14. DESCRIPTION OF AMENDMENT/MODIFICATION (Organized by UCF section headings, including solicitation/contract subject matter where feasible.)							
Rehabilitate Elk Creek Visitor Center (CURE 187989)							
The purpose of Amendment 0003 to solicitation 140P2020R0048 is to do the following:

1. Provide Questions and Answers. Attachment titled "0003-Q and A Rehabilitate Elk Creek Visitor Center.docx," dated July 21, 2020, is hereby incorporated and made a part of this solicitation.

ELK CREEK V.C.
CURECANTI NAT. REC. AREA
7/16/2020
By: DMD

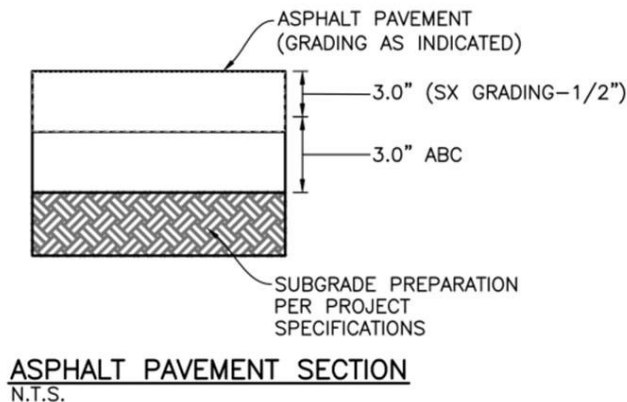
Q44: Sheet AD1.0 keynote D-39 calls for removing the pad under the existing CMU enclosure. What are the dimensions of the pad that needs to be removed?

A44: Keynote D39 coincides with keynote D35 (D39 is not shown in the correct location on the demo plan).
